HIROSE ELECTRIC CO., LTD.
2-6-3 Nakagawa Chuoh, Tsuzuki-ku, Yokohama, JAPAN

Product Specification Change for HIF3, B, C, M, and FX2B Series

Supplementary Documentation for Product Changes in HIF3, B, C, M and FX2B Series

Product Name and Changes of the Modified Items

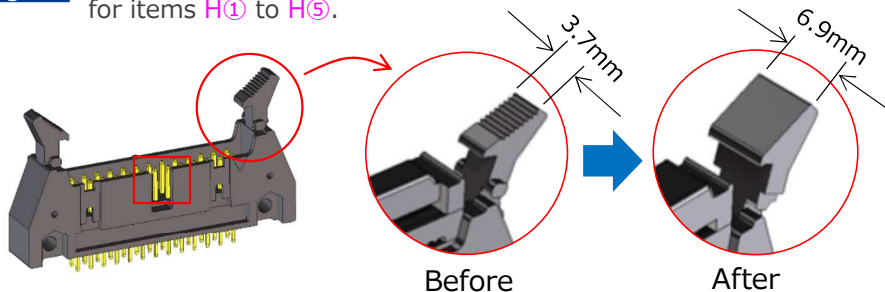
2.54mm Pitch Board-side Pin Header Group							2.54mm Pitch Cable Press-fit Socket Group
H① HIF3M*W-PB -2.54DSA	H② HIF3M*W-PB -2.54DS	H③ HIF3M*W-PB -2.54WB	H④ HIF3M*W- ****PB-2.54DS	H⑤ HIF3MC*W-PB -2.54DSA	H⑥ HIF3M*W-PB -2.54DSA	H⑦ HIF3M*W-PB -2.54DS	H⑧ HIF3M*W-D -2.54R
Wide lock shape, straight type	Wide Lock Shape, Angle Type	Wide Lock Shape, Long Lead Angle Type	Wide Lock Shape, Double Layer, Angle Type	Wide Lock Shape Flux, Anti-Climb Straight Type	Wide Lock Shape Straight Type	Wide Lock Shape Angle Type	Wide Clamp Shape Type
[Changes] •Wide Lock Shape •Change in Terminal Plating Specifications					[Changes] •Change in Terminal Plating Specifications		[Changes] •Wide Clamp Shape •Change in Terminal Material •Change in Terminal Plating Specifications

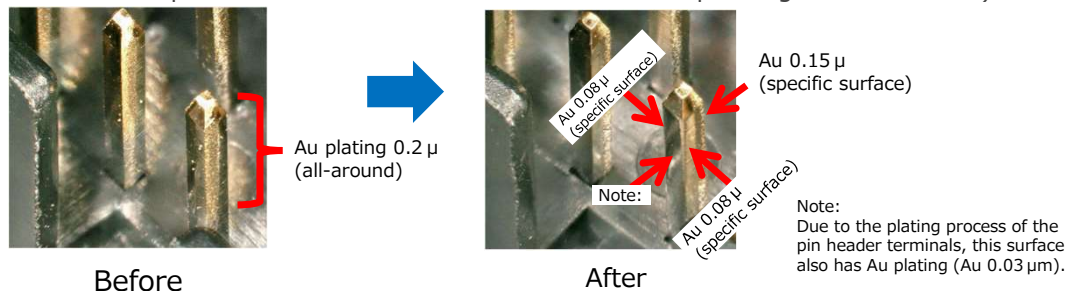
Change 1 Change the lock shapes from standard width to wide shape type for items H① to H⑤.

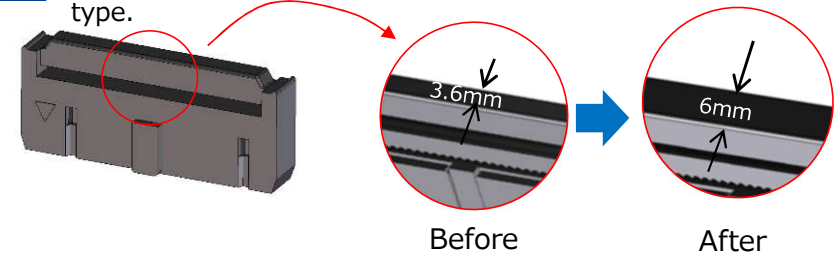
Change 2 Change in plating specification for the contact area of pin header terminals H① to H⑦. (Change from full-surface Au 0.2 μm plating to a specification with different Au thicknesses depending on the surface.)

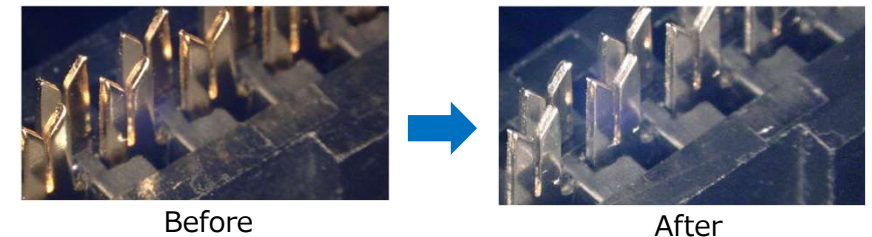
Change 3 H⑧ Change the clamp part of item ⑧ from standard width to wide type.

Change 4

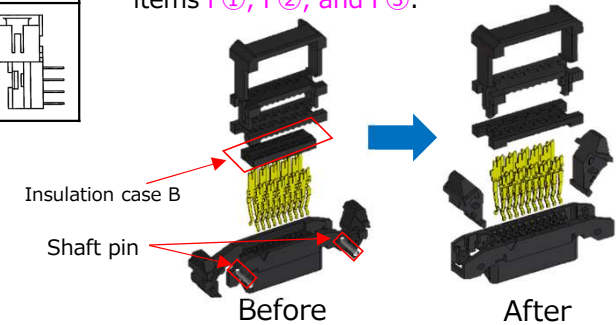
Change the number of parts used for items F①, F②, and F③.

Change 6

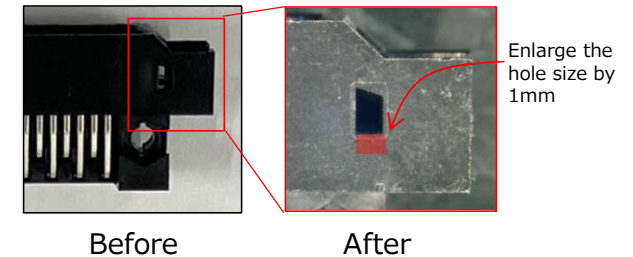
Change the hole size on the side of the insulation case for item F⑤.

Change 2

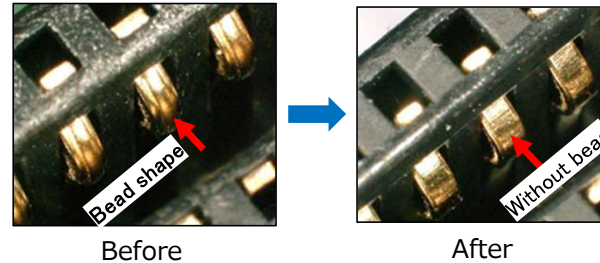
Change the terminal material of items F①, F②, and F③ (within copper alloy types) and modify the contact area shapes.

Change 3

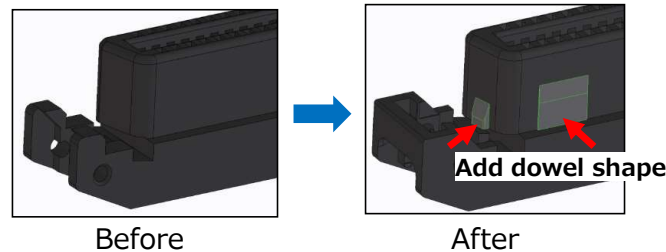
Change the side shapes of the insulation cases for items F①, F②, and F③.

Change 1

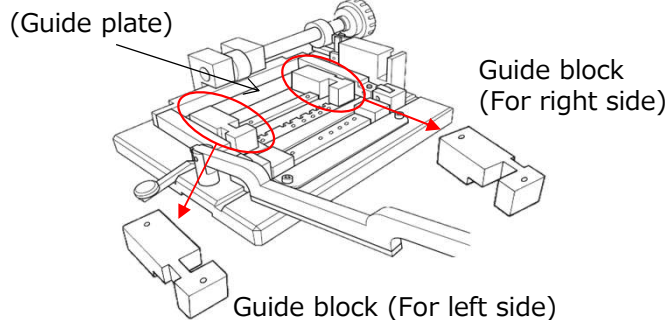
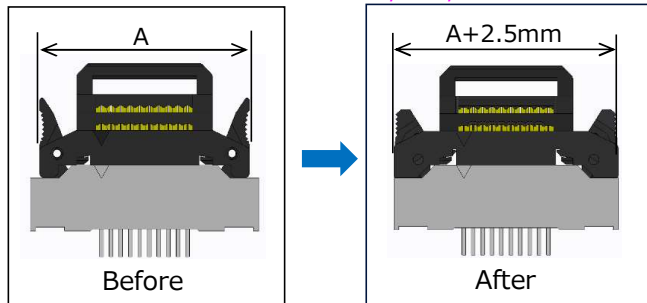
Change the lock shapes and external dimensions for items F①, F②, and F③.

It is necessary to purchase an additional set of guide blocks (left and right).

Part number for the left guide block: FX2BR-GPA(71)

Part number for the right guide block: FX2BR-GPA(72)
